PCN	Product Change Notification	De-23-010-0716	
Product	SRC MiniBridge	Date of Publication:	
		13.10.2023

**Title:** Change of Tray width

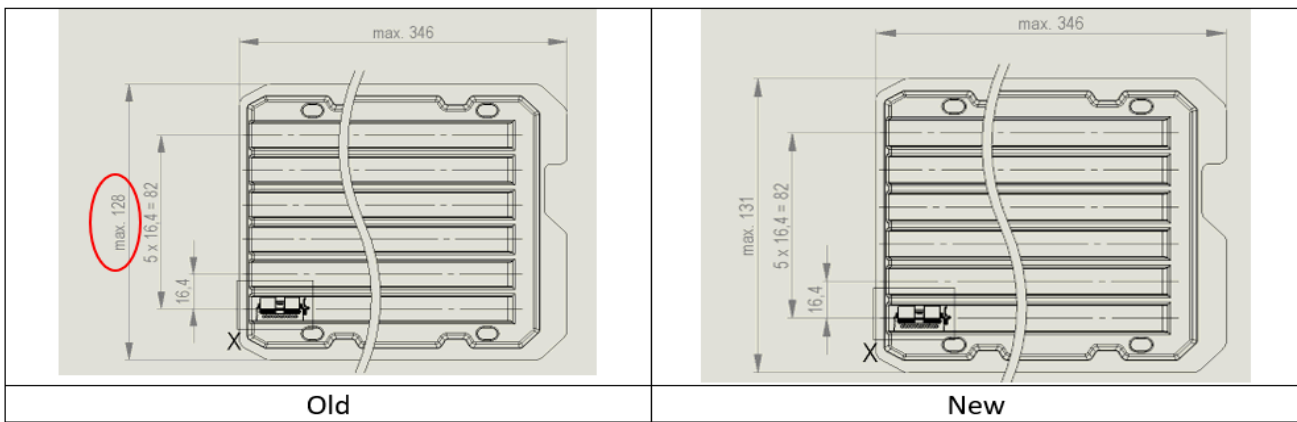
Valued customer,  
to improve the quality of our MiniBridge Tray packaging we change the width from max. 128mm to max 131mm as shown on the picture below.

This change will not affect reliability of product and will be operated without partnumber change. It will not effect form fit or function of the MiniBridge Connectors, only the form of the Tray packaging.
